Plan Review Resubmittal

Re: 905 North Avenue
Building Permit #: COM-2307306
Address: 905 North Avenue

OFF-SITE IMPROVEMENT PLANS FOR
NERRADSCALI SUBDIVISION
SACRAMENTO, CA 95838
APN: 237-0200-092

DRAINAGE STUDY AND STORM WATER QUALITY CONTROL PLAN

GRADING, DRAINAGE
AND PAVING PLAN

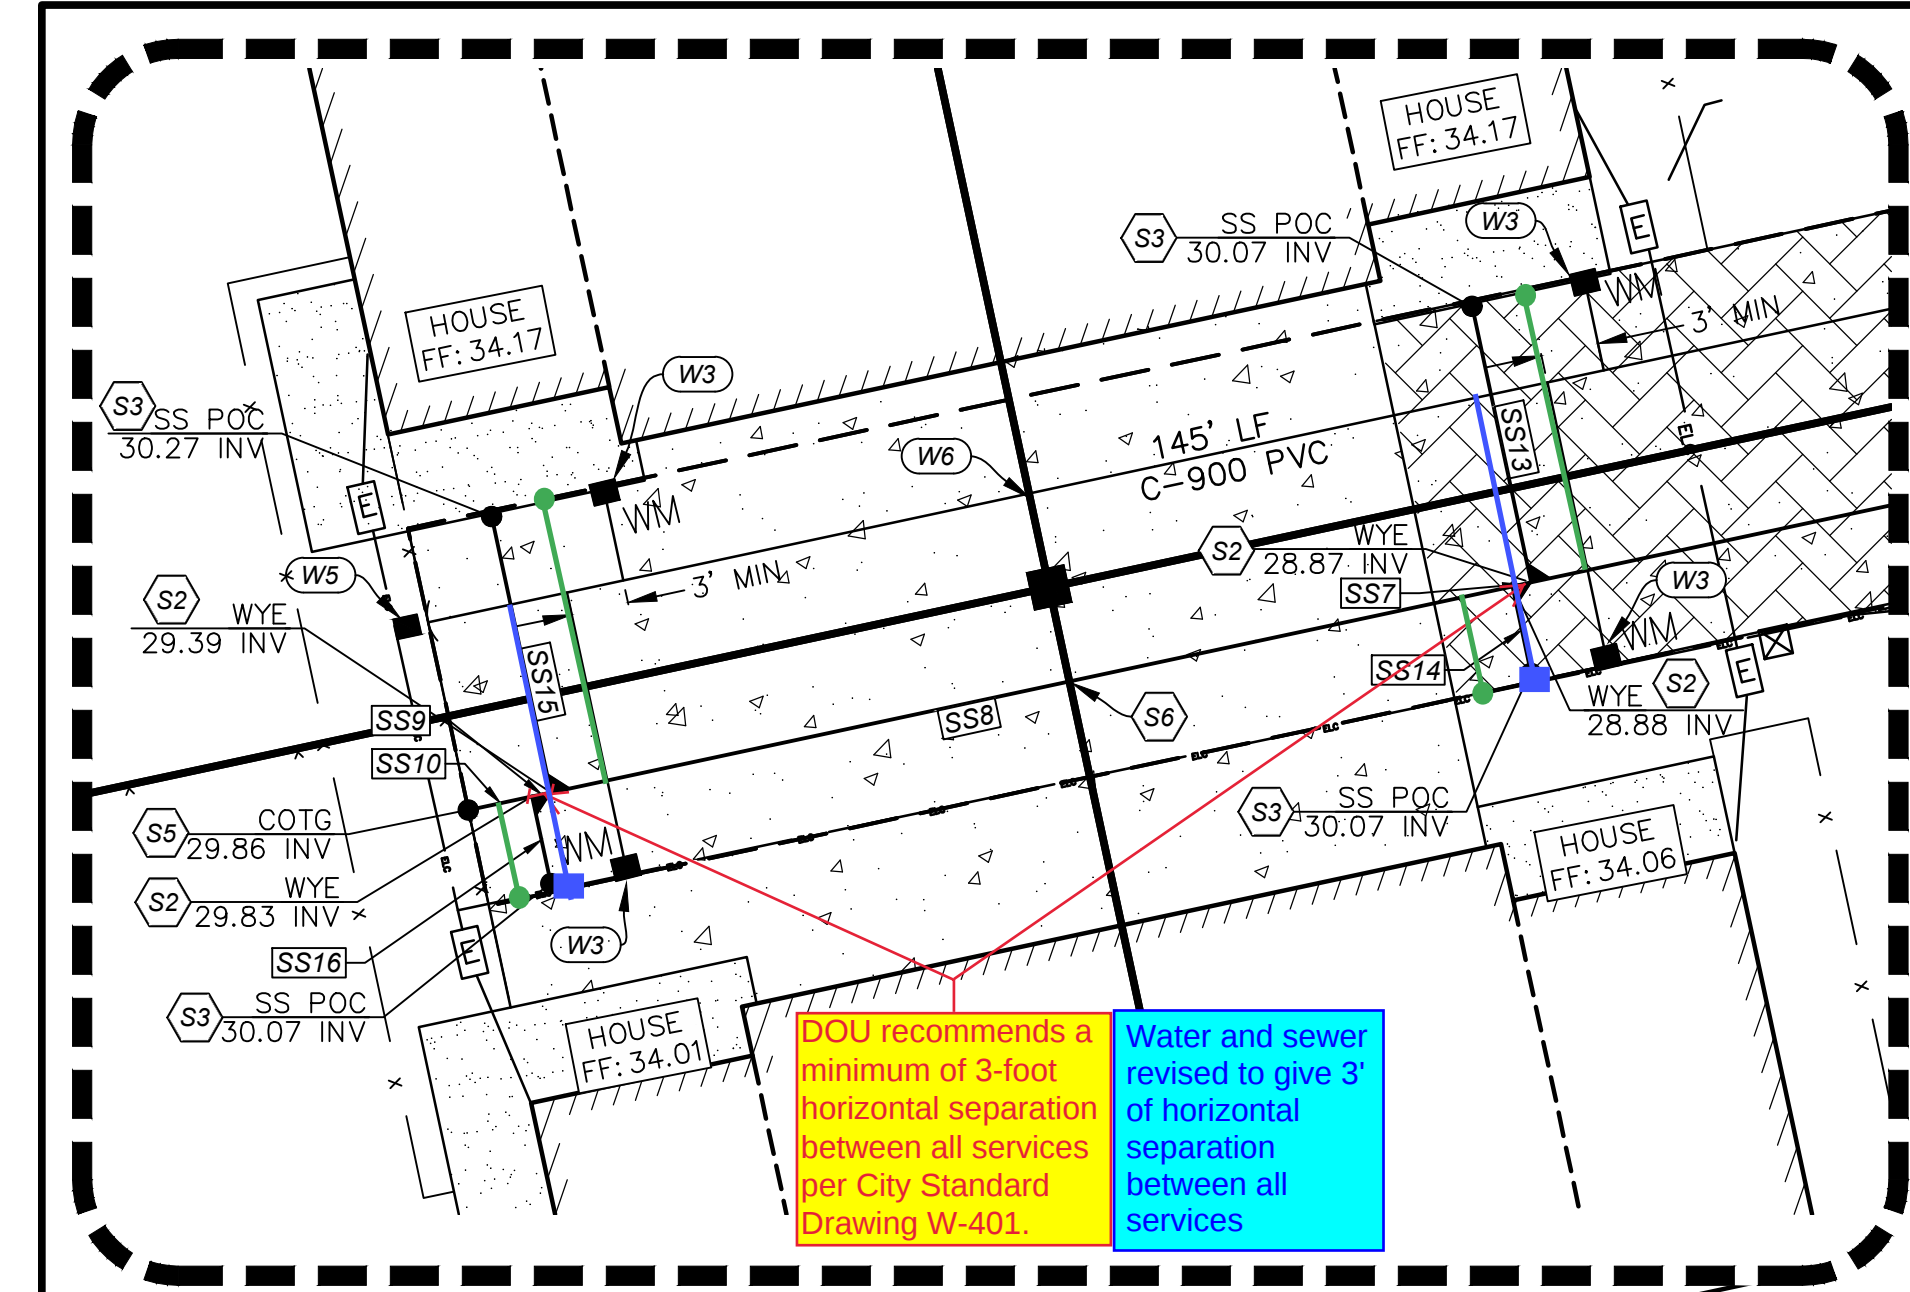
Grading sheet shall show existing and proposed elevations, grade breaks, finished floor elevations and overland flow release arrows; pavement information, including curbs, gutters and sidewalks; and surface stormwater quality features. Cross sections showing existing and proposed grading, fences, walls, property lines, right-of-way, easements, drainage flow arrows, utilities, dimensions, and finished pavement sections and base information.

Also please clarify how the flows are being restricted.

Change the layer for the property lines to differentiate from the drainage pipe.

Call out the detail for this landscape drain inlet.

Use standard manhole 3A per City Standard Drawing S-80, when greater than 8-feet deep and less the 27" diameter.

Revise pipe material accordingly.

All items listed in Section 3.3 of the City of Sacramento DOU Onsite Design Manual are shown on either this sheet or C6.2.

Per the design, the flows shall be restricted at the point of service manhole, see attached detail.

Property line that crosses directly over storm drain pipes is now hidden on this sheet. Note added to provide clarity.

Landscape drain inlet has been updated to: 24" Nyloplast drain basin (or approved equal). Per Lorenzo Hernandez of City of Sacramento, the City does not have a specific detail for a landscape drain inlet, so a general call out is used.

Revised to Standard Drawing S-80. Detail 4 on sheet C10.2 also updated.

Pipe material revised from HDPE to PVC.

ON-SITE IMPROVEMENT PLANS FOR
NERRASCALI SUBDIVISION
SACRAMENTO, CA 95638
APN: 237-0200-092
UTILITY PLAN

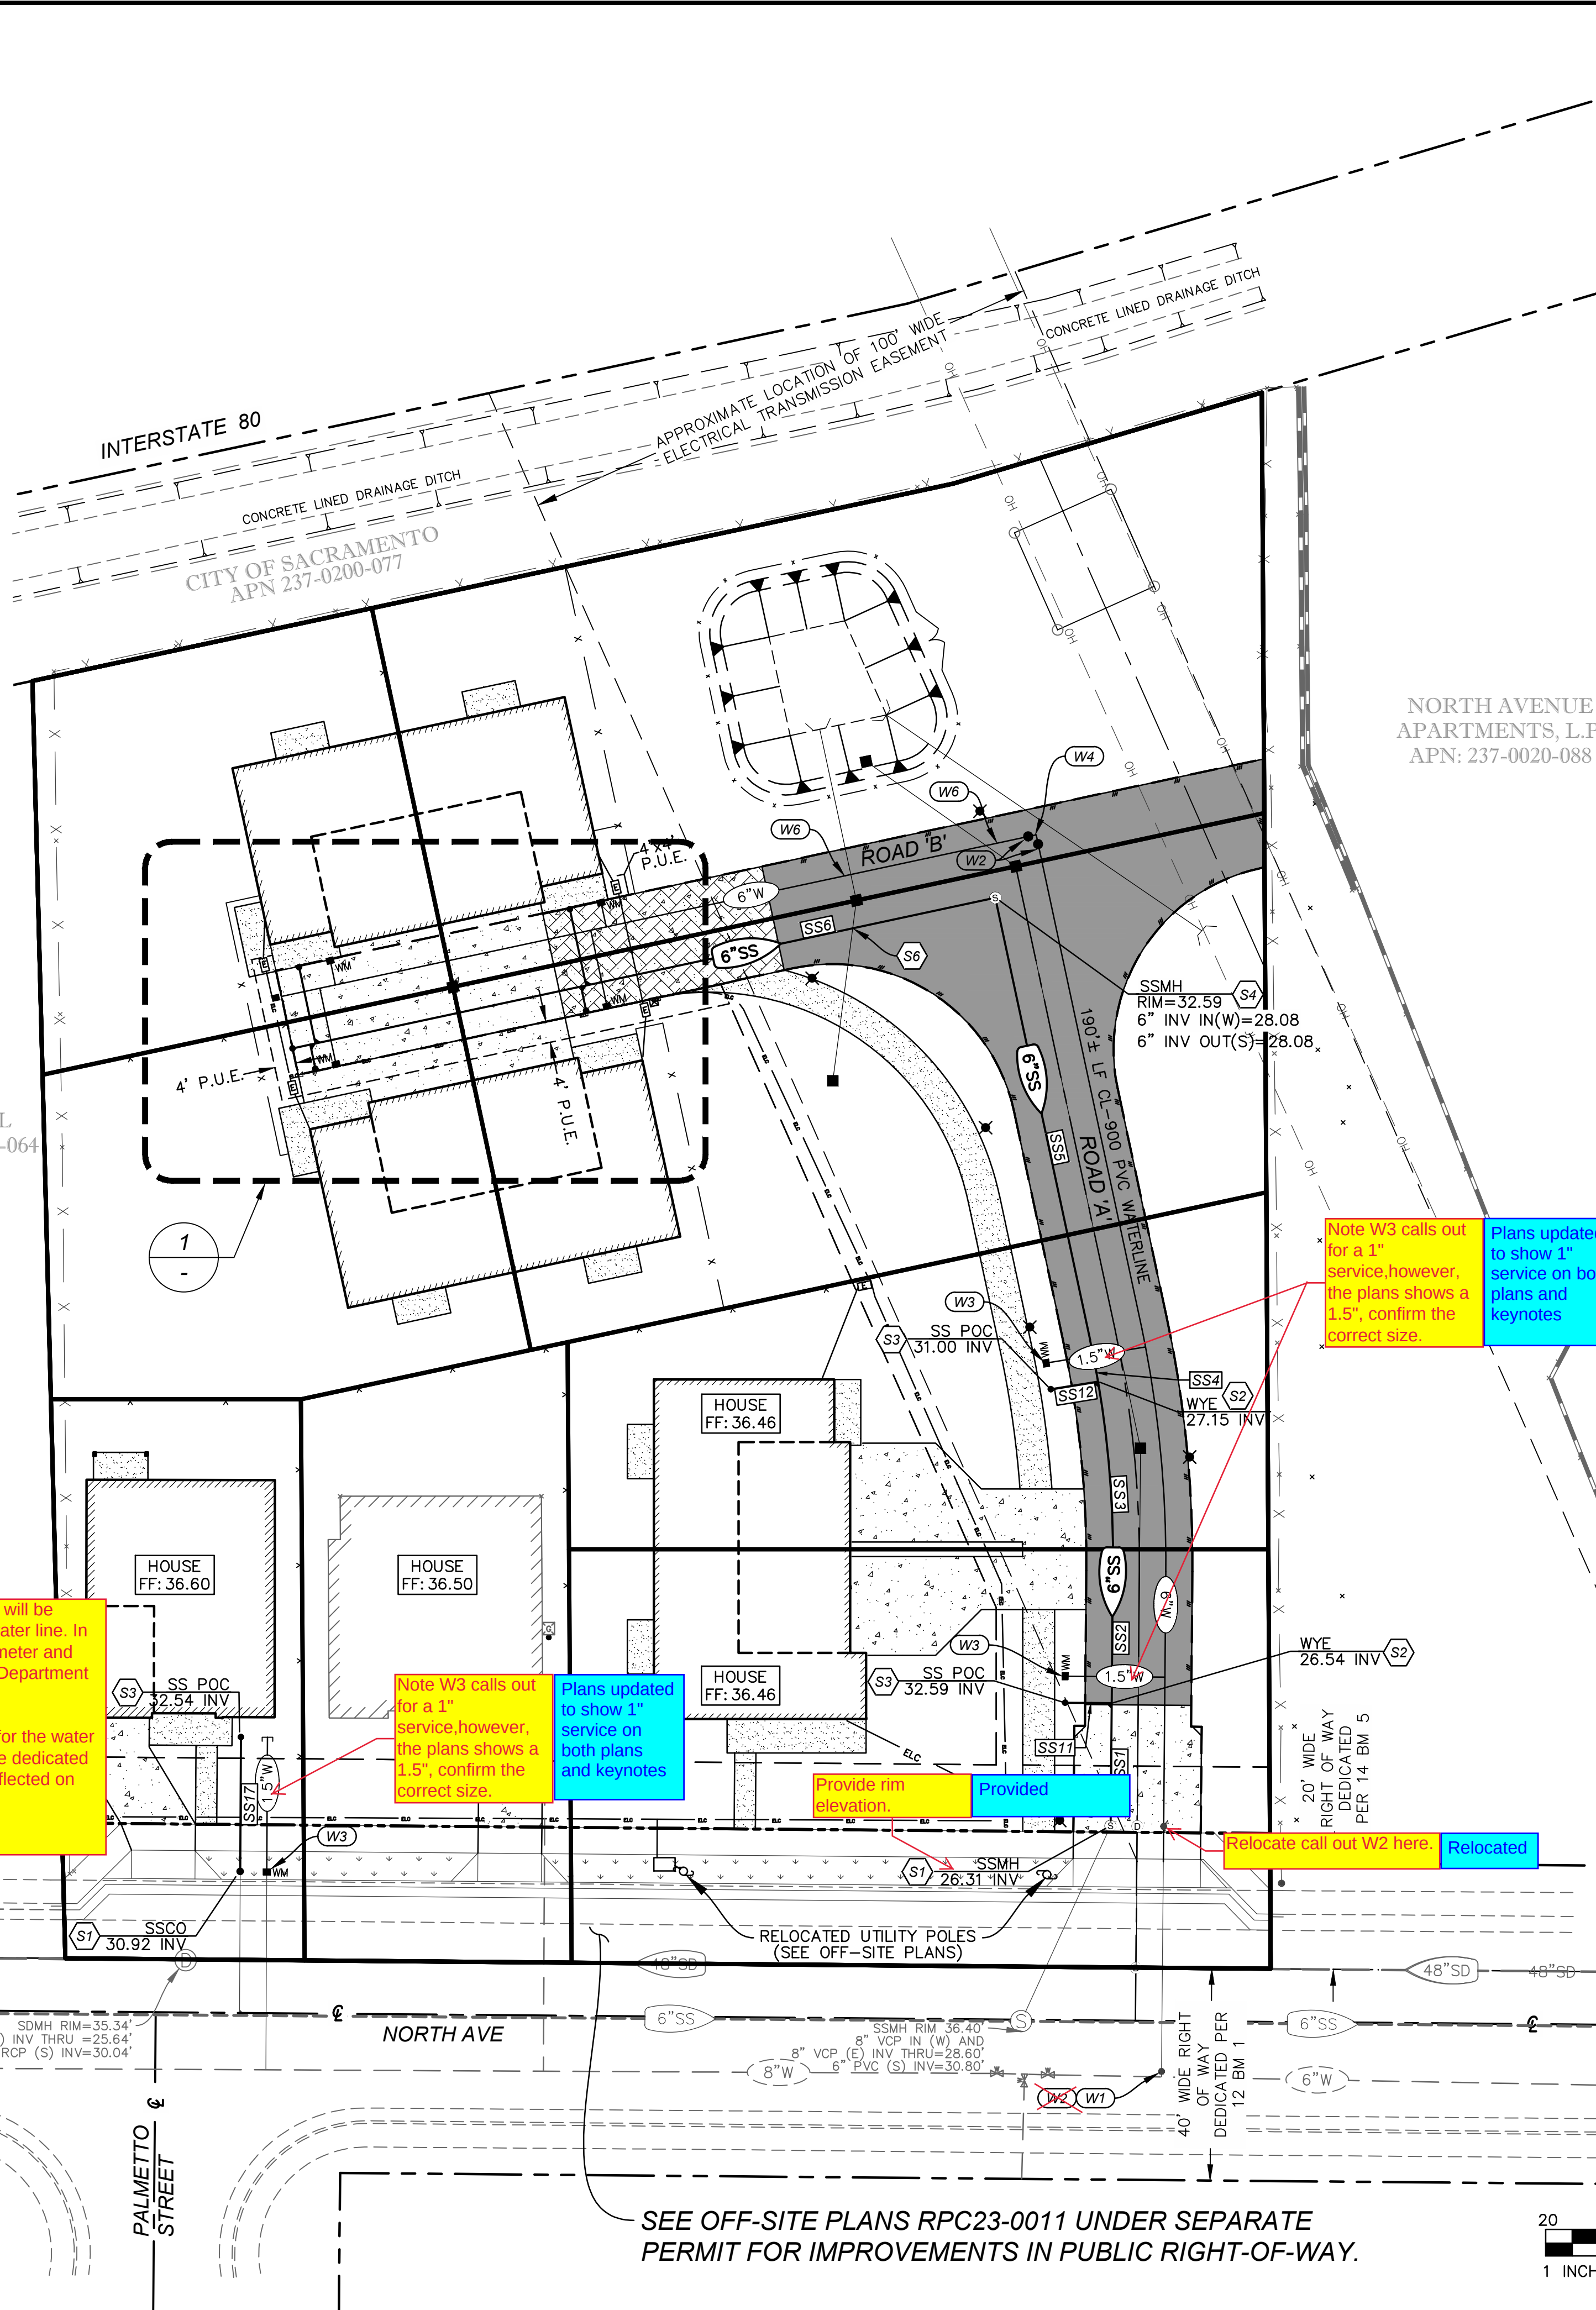
Provide an update on the easement for the water meters. If the easement is going to be dedicated with final map, make sure that it is reflected on the map.

Note W3 calls out for a 1" service, however, the plans shows a 1.5", confirm the correct size.

Provide rim elevation.

Private reciprocal easement for water facilities referenced, see Note A on page 10 of Attachment 3 - Final Map.

Plans updated to show 1" service on both plans and keynotes
